**Overview:** The initial production release of the FTI-TLK1 harness has an issue where in some vehicles the secondary power input to the CN1 connector will overload the associated vehicle circuit, causing a fuse to blow. This issue affects the initial release of harnesses and is already being addressed in production. A field correction procedure is detailed below in Figure 1.

# FTI-TLK1 Type 3A1 - Vehicle Coverage & Preparation Notes

**Figure 2: Supplied CN1 Harness Adapters**

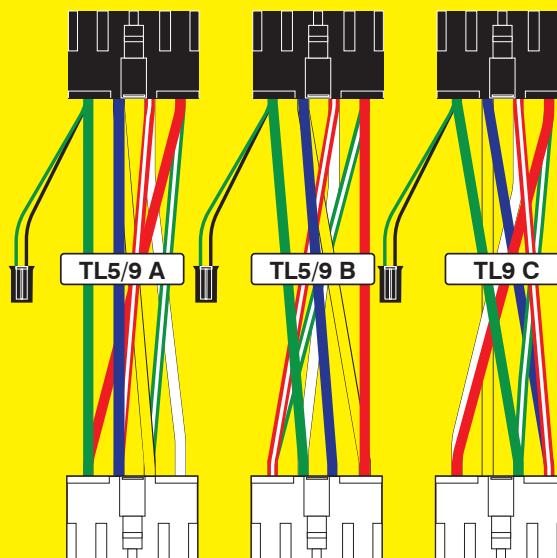
**Issue:** The secondary power circuit can overload some vehicle ignition switch circuits, causing a blown 5A/7.5A AM1 fuse, potentially disabling the vehicle and leaving the consumer stranded. Affected adapters are illustrated below in figure 2.

Incorrect power provisions with the potential to overload vehicle ignition supply circuit, resulting in blown AM1 fuse.
